September 11, 2021

Subject: Submittal of Comments on Final Environmental Impact Statement (FEIS) for Interim Storage Partner's (ISP's) License Application for a Consolidated Interim Storage Facility (CISF) in Andrews County, Texas, Docket ID NRC-2016-0231

Final Environmental Impact Statement Review for Consolidated Nuclear Storage Facility, Andrews County, TX

Figure 2: Cumulative Impact Radii from ISP FEIS (NRC 2021)

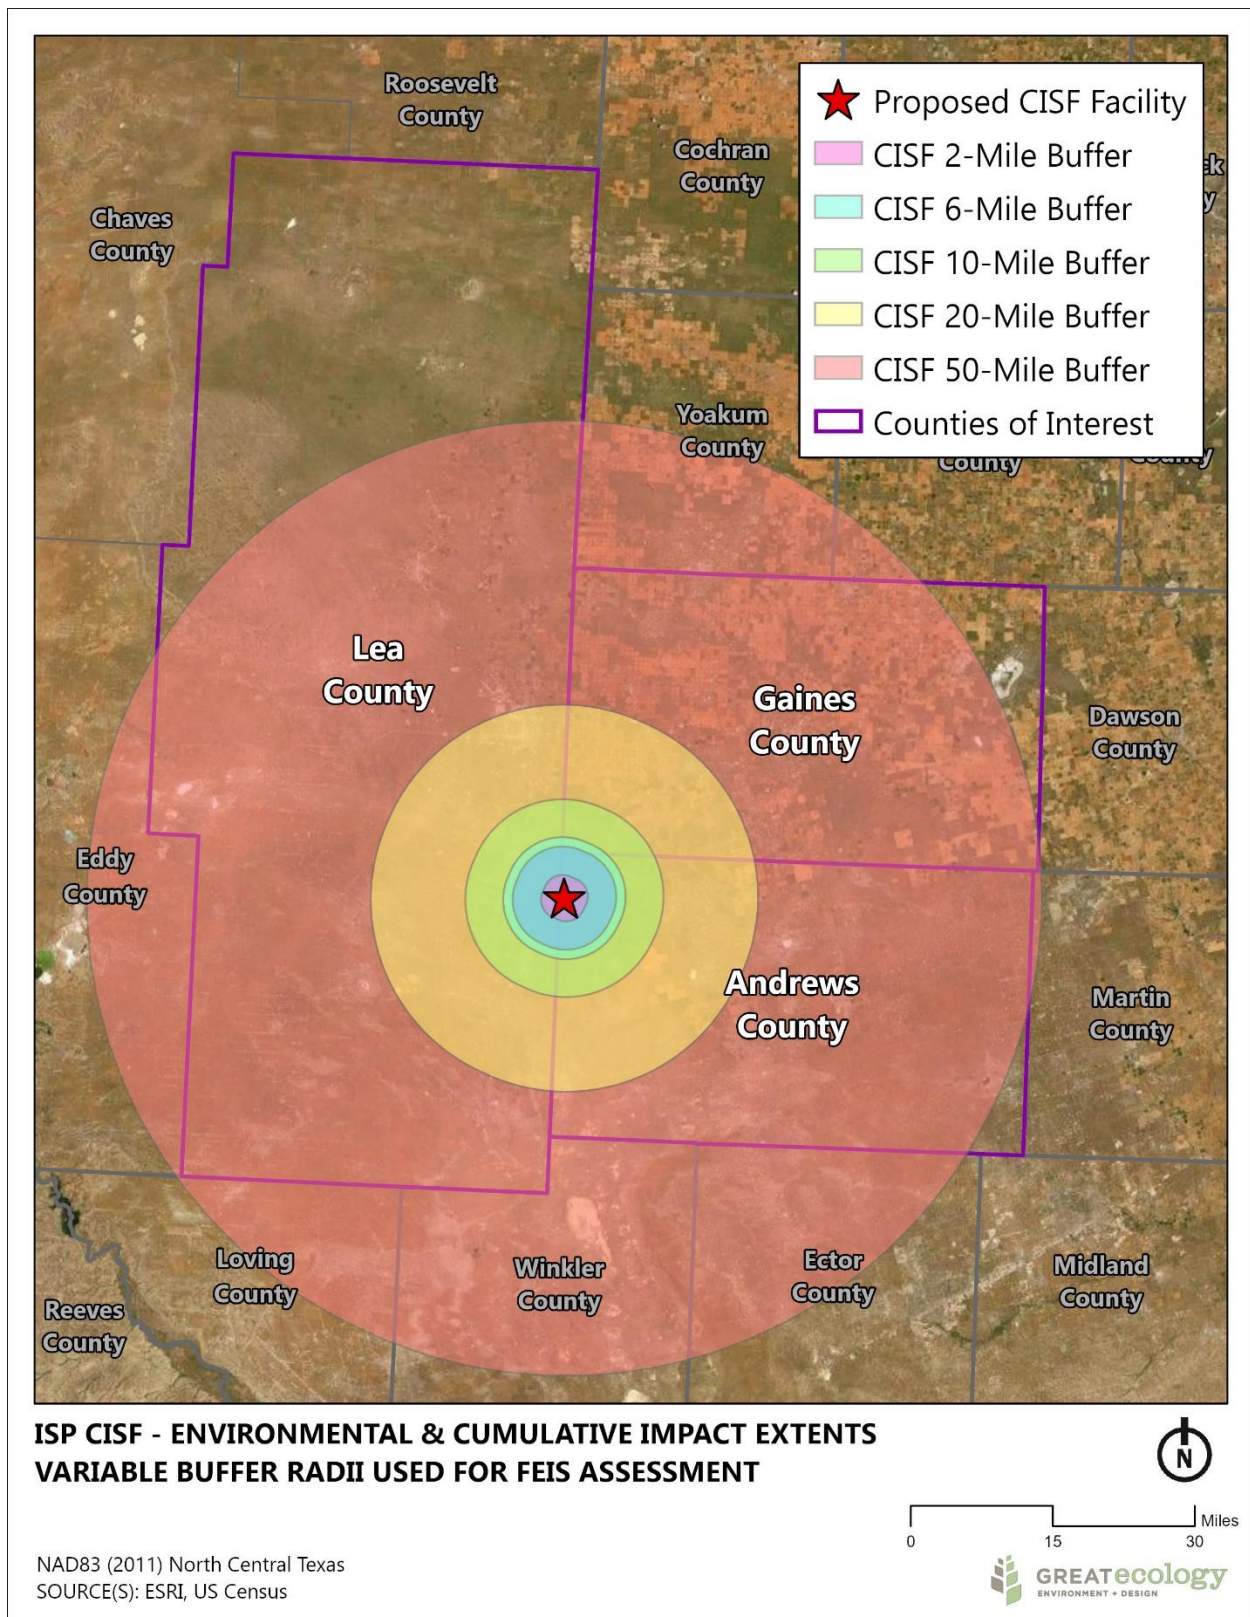
The FEIS arbitrarily identifies a 20-mile cumulative impact evaluation radius for groundwater from the ISP Project. The FEIS further states that, of the nuclear facilities in the region only the existing Waste Control Specialists (WCS) facility, National Enrichment Facility (NEF), and Eden Radioisotopes are within the 20-mile groundwater study area. By arbitrarily limiting the study area dimensions, thorough evaluation of cumulative impacts of ISP and other past, present, and reasonably foreseeable projects to groundwater resources are precluded. As the Permian Basin Coalition and Fasken Land and Minerals' previous comments on the ISP draft EIS (PBLRO & FLML 2020) noted, the geographic formation (Central Basin Platform) is heavily-faulted and the Project's seismic hazard analysis was deficient. The PBLRO/FLML letter also calls attention to the ISP environmental analyses' failure to mention and characterize the Rio Grande Rift (RGR), which it characterizes as critical in understanding the geological and geohydrological history of the aquifers at the CISF and potential risks to groundwater resources and seismology (PBLRO/FLML 2020). In light of the analysis' arbitrarily limited spatial scale in a region of obvious seismic risk, evaluation of cumulative impacts to groundwater resources is clearly inadequate.

Once again, the FEIS arbitrarily identifies a small, 5-mile cumulative impact evaluation radius for wildlife from ISP Project. NRC states that their ecological cumulative impacts analysis is "limited to this radius because ecological resources are not anticipated to influence or to be influenced by the proposed CISF project outside of this area." This statement is not supported by any real scientific evidence and does not consider the wide ranges of several species with the potential to occur onsite. Migratory birds would most certainly be impacted outside of a 5-mile radius from the project, along with any highly mobile species.

Figure 3: Nuclear Reactor Sites throughout the United States and Nationwide Railroad Network

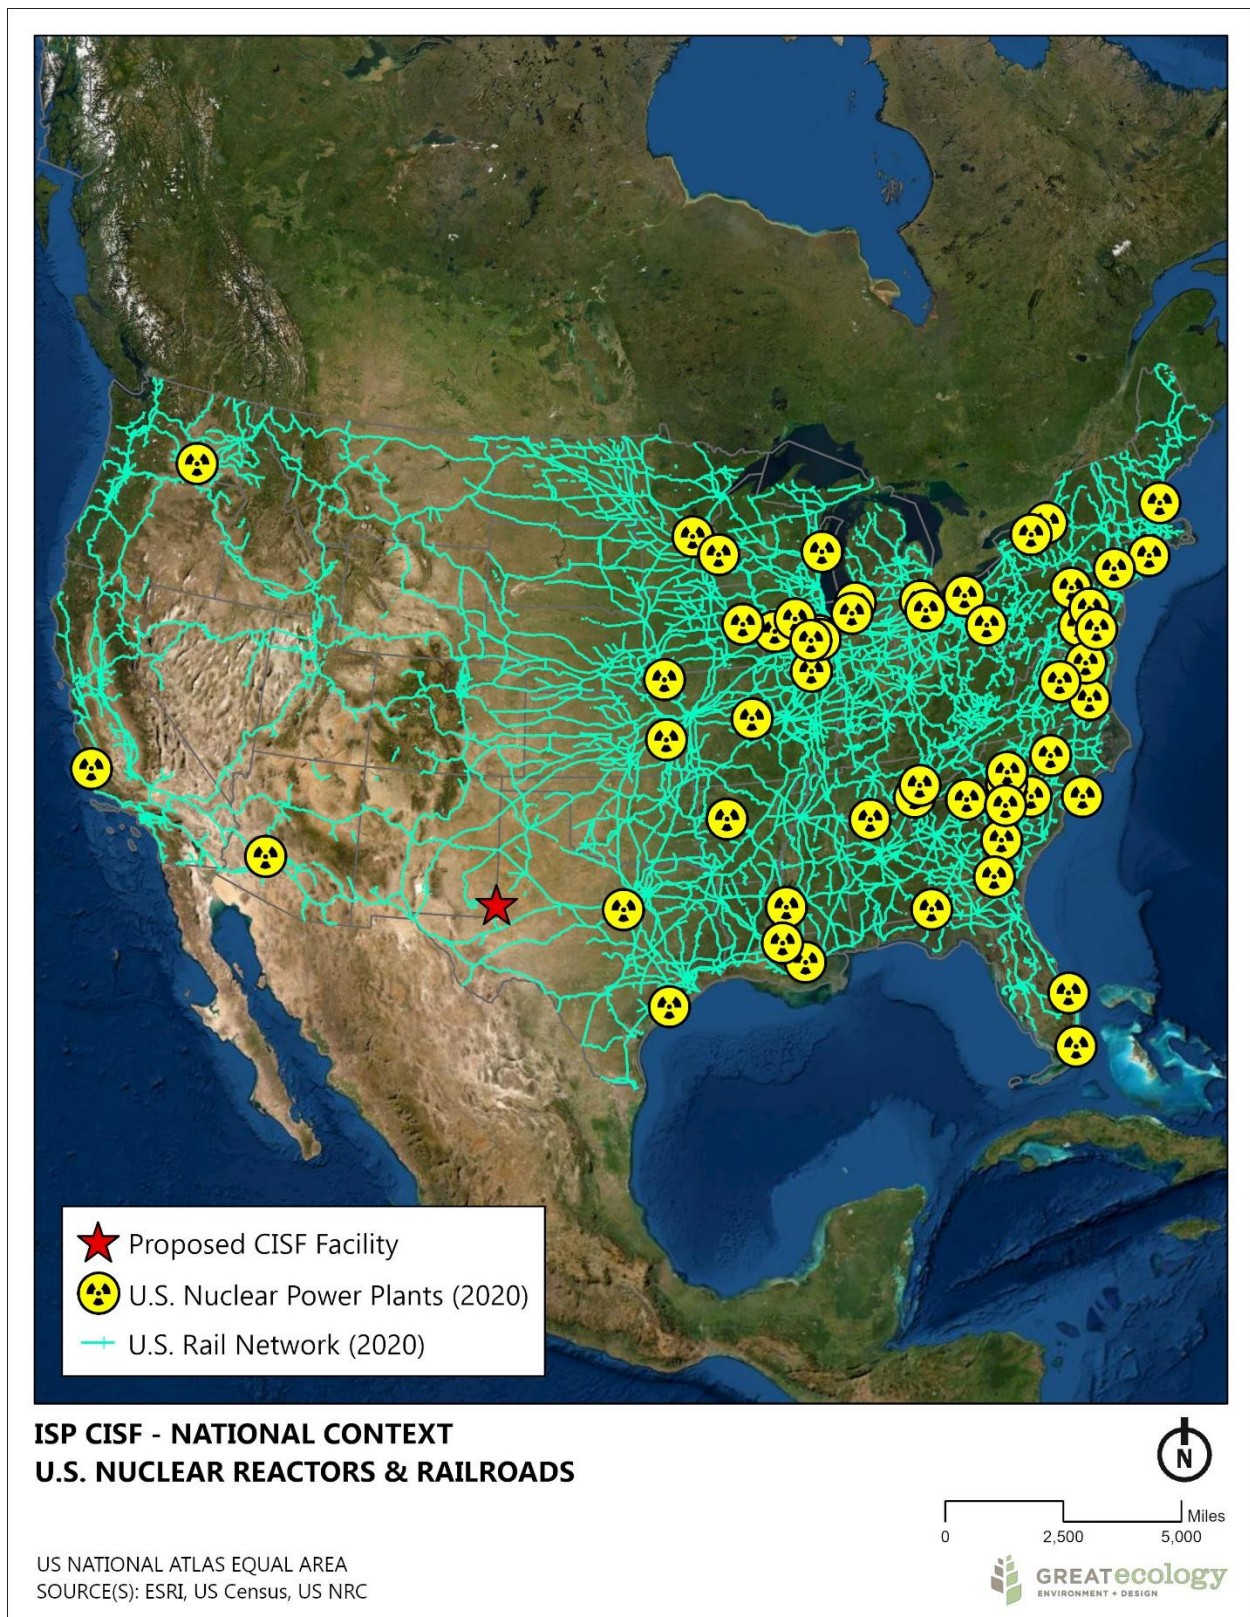
The FEIS also downplays the nationwide extent of where HLW would be arriving from, since HLW is currently stored at nuclear energy facilities dispersed throughout the country. FIGURE 3 shows the locations of nuclear reactor sites across the US, along with the railroad network that would need to be utilized to transport waste currently existing at these sites. Illustrations and figures in the FEIS do not show the true breadth of this problem, and instead separately show the rail network and decommissioned nuclear power plants (FIGURE 4). HLW is spread throughout the country, and the extent of its transportation to the ISP CISF facility has a much larger impact (and would be more than 'incremental') than the FEIS presents. It also ignores what the surrounding local community looks like, and what sensitive receptors could be most impacted. FIGURE 5 depicts several facilities with vulnerable populations in the area (an extrapolation of the rail network presented by NRC in FIGURE 4); many of these sensitive receptors are located quite close to the railroads in the area. Should any accident occur in the future, these people would certainly be impacted quite heavily.

Figure 5: Sensitive Receptors Close to the ISP CISF and Regional Railroad Network

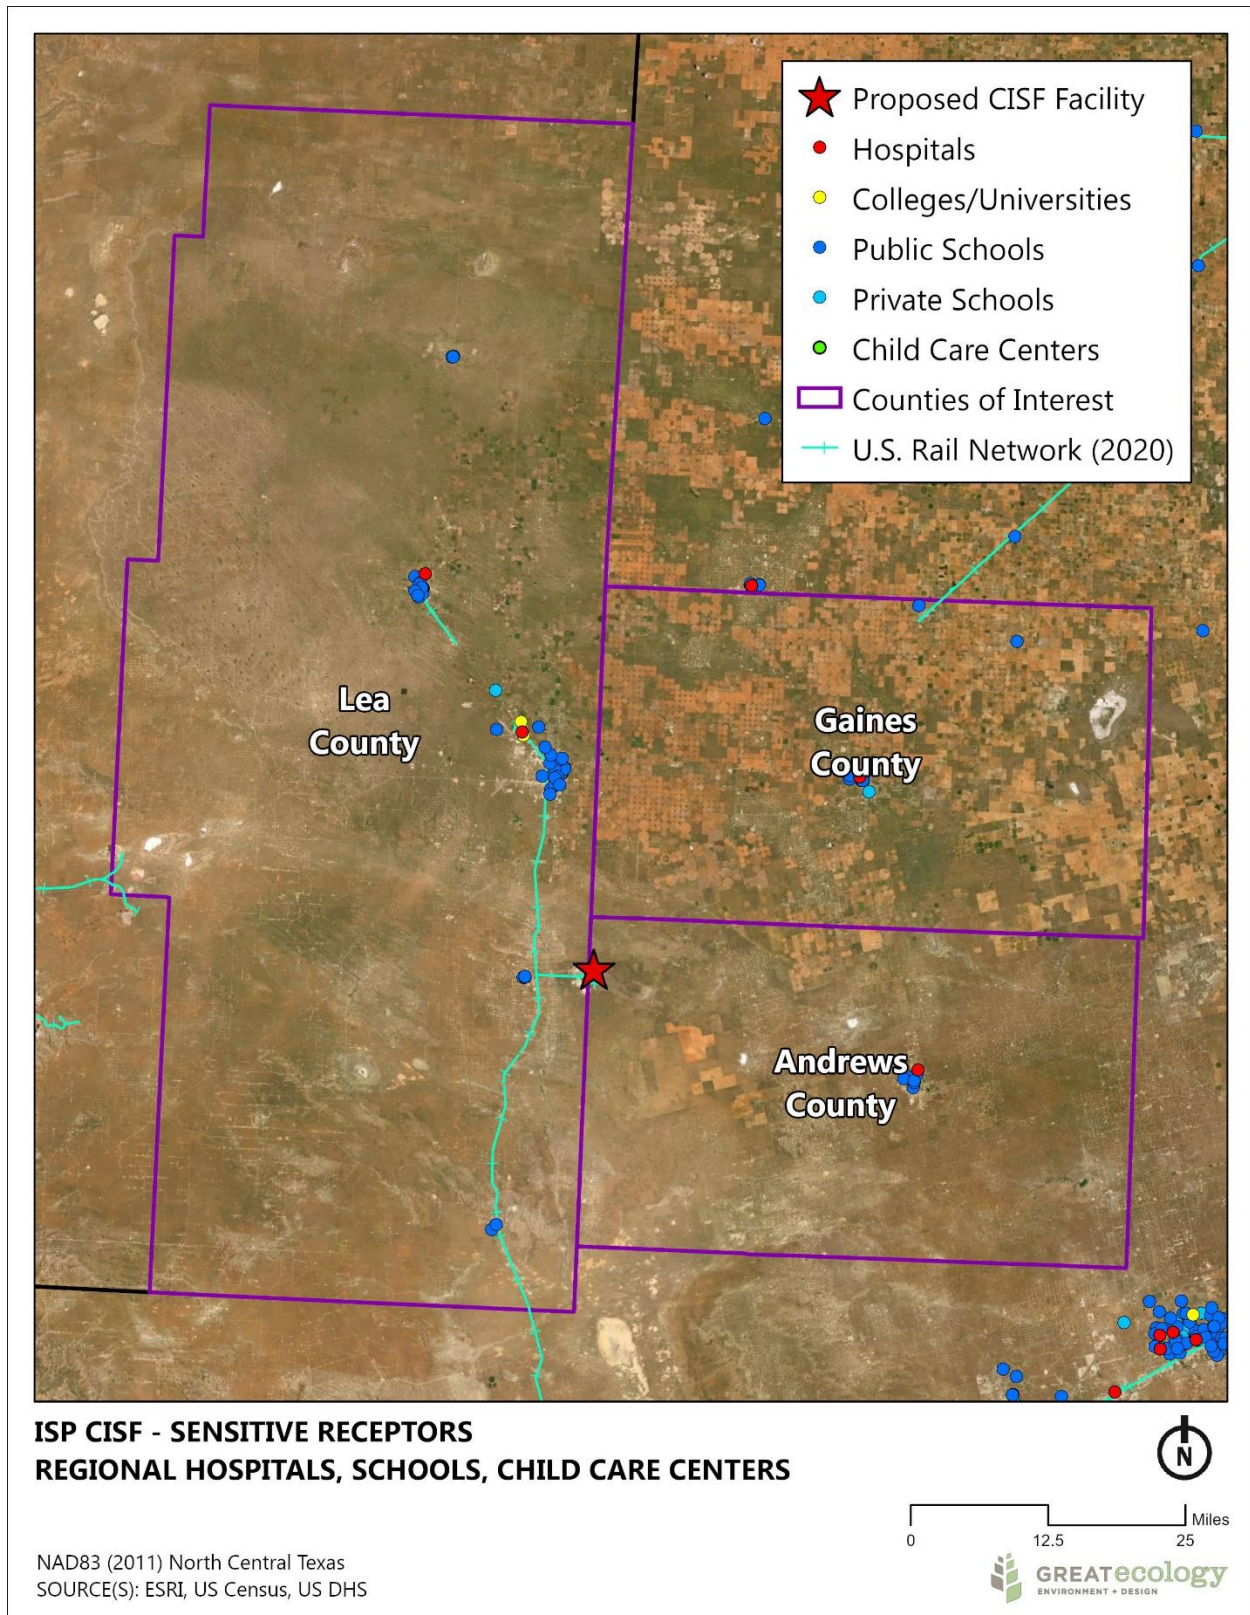
The FEIS assumes all effects from transportation would be incremental over time. This does not appear to be the case as this facility would increase the region's importance as a HLW storage and disposal destination increasing traffic volumes in a more than incremental manner. In addition, the arbitrary radius imposed on the cumulative impact assessment does not appear to appropriately consider the national and regional sources of HLW and long-distance freight system impacts.

Figure 6: Current Species Ranges for Northern Aplomado Falcon and Pronghorn Antelope

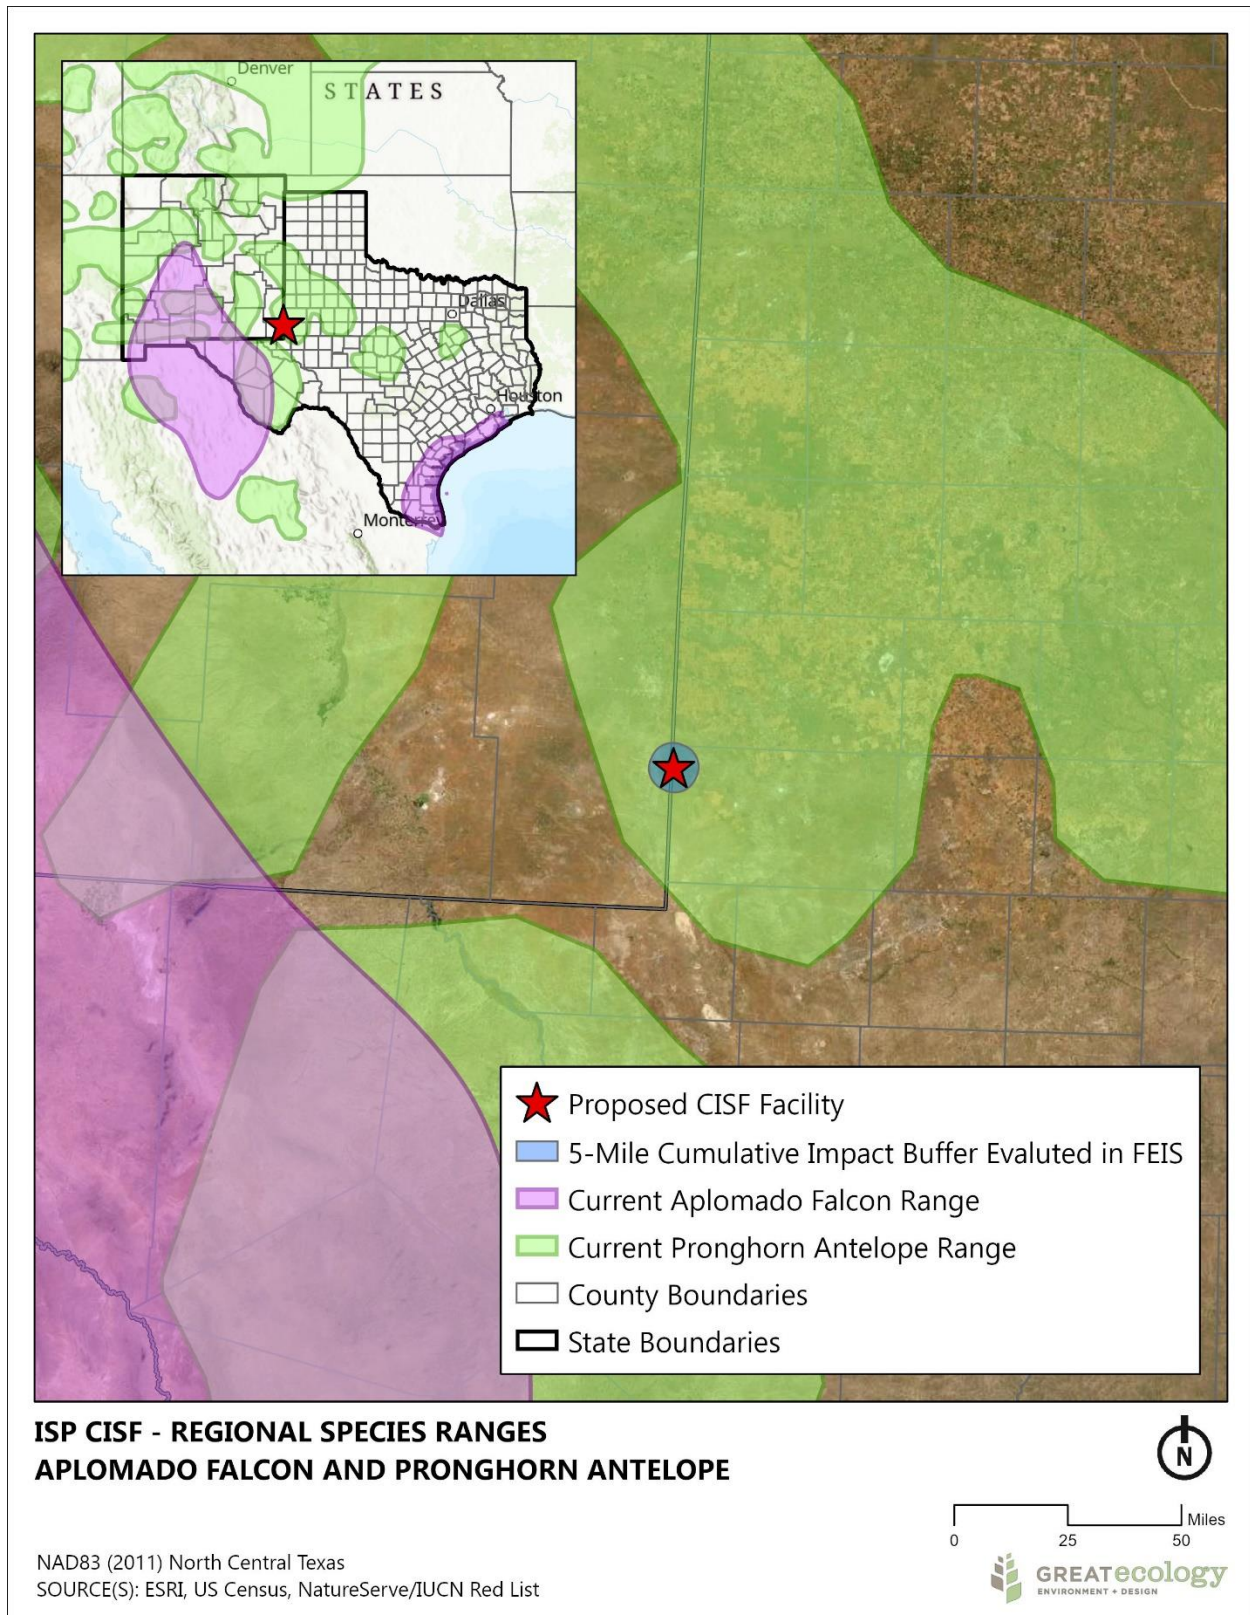
We discuss two species with wide-reaching ranges that were not examined thoroughly as part of the ecological cumulative impacts analysis: the endangered northern Aplomado falcon (*Falco femoralis septentrionalis*), and a regionally important game species, the pronghorn antelope (*Antilocapra americana*). Both species have a much wider reaching range than five miles, which is not captured by the FEIS cumulative impact radius (FIGURE 6).

Similarly, the pronghorn antelope is a highly migratory game species which ranges across the southwestern U.S. It is an important, state-managed game species in both Texas and New Mexico which attracts hunters and wildlife enthusiasts to the region. Because of this, the herds of pronghorn antelope possess interstate commerce value as harvestable game. The proposed project, as well as other past, present, and reasonably foreseeable future projects (and their freight and construction traffic) would result in fragmentation of pronghorn antelope range and loss of habitat connectivity, potentially affecting the management and viability of herds migrating in both states. Habitat fragmentation and cumulative project impacts to migratory corridors for pronghorn antelope and other wide-ranging species are not discussed in the FEIS.

Figure 7: Predicted Habitat Map, Northern Aplomado Falcon (USGS GAP 2021)

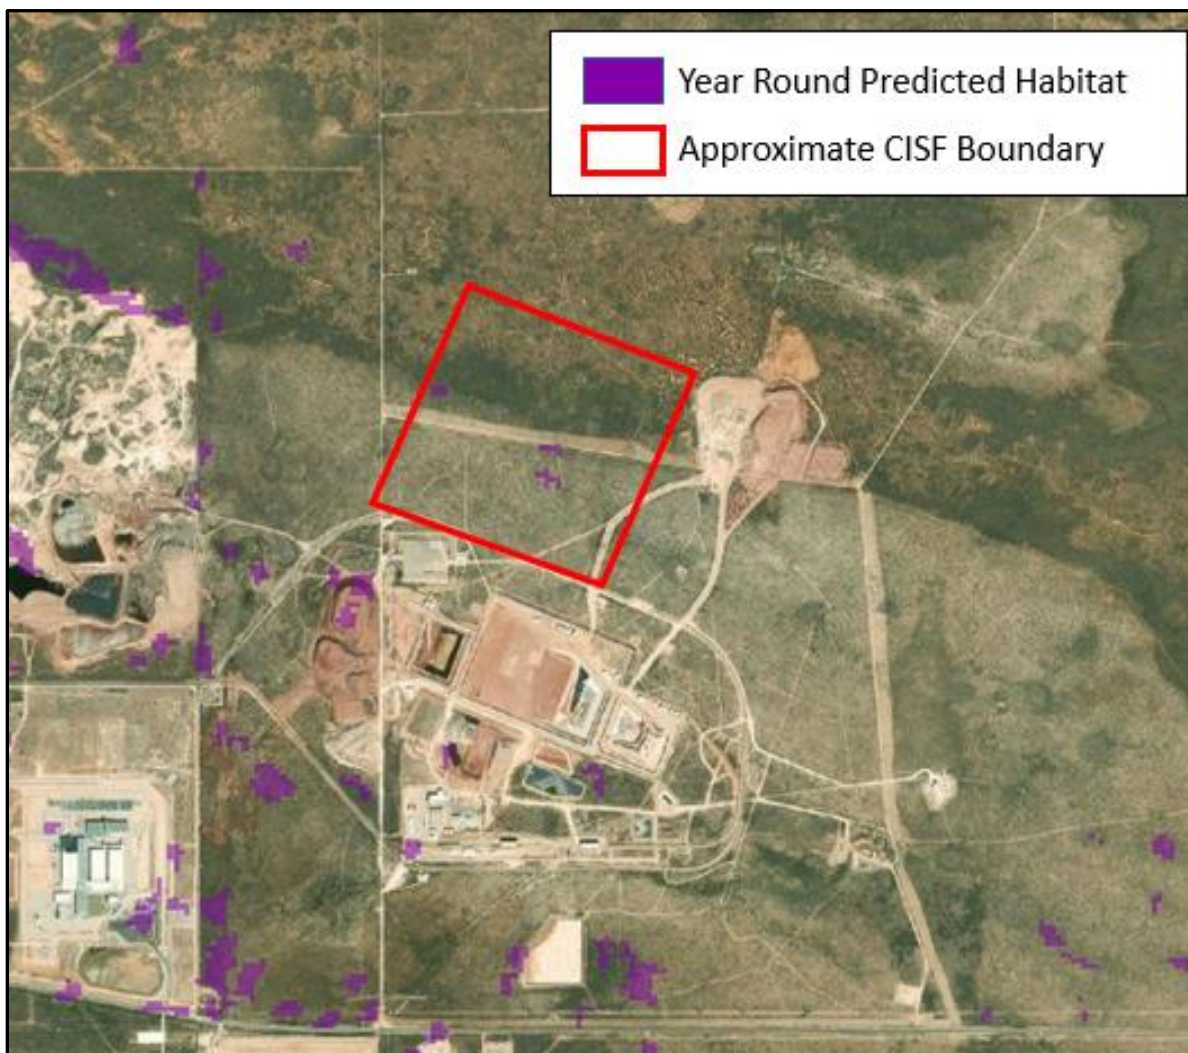
The U.S. Endangered Species Act of 1973 (ESA) regulates the 'take' of federally-listed threatened and endangered species. One federally-listed endangered species has a known range that includes the ISP Project site and surrounding environs (FIGURE 7). The northern Aplomado is a federally-listed Endangered Species with mapped range in western Texas and eastern New Mexico and a published Recovery Plan (USFWS 1990). The ESA has a recovery standard: in other words, the goal of the ESA is to recover a listed species to the point at which it can be delisted. This project, as well as other past, present, and reasonably foreseeable future projects in the region would together have cumulative impacts across a fairly substantial part of the historical former range of the species precluding the recovery of the species. Since this project is located within the species' historic range, it follows that destruction of habitat would inhibit the recovery of this species and potential future delisting. The FEIS does not evaluate or address the recovery plan currently in place for this species and needs a more thorough analysis of the ESA relating to the northern Aplomado falcon.

The project site was identified within the habitat range for northern Aplomado falcon, a federally- and state-listed endangered species. The falcon nests in abandoned nests created by other raptors; these inactive nests were observed onsite during the most recent ecological survey (CMEC 2019). The FEIS assumes that the project will have no impacts on the Aplomado falcon; however, this analysis shows a very limited scope of evaluation under the ESA, in particular with respect to identifying obstacles to species recovery. This is discussed further above as a deficiency in evaluating cumulative impacts under NEPA.
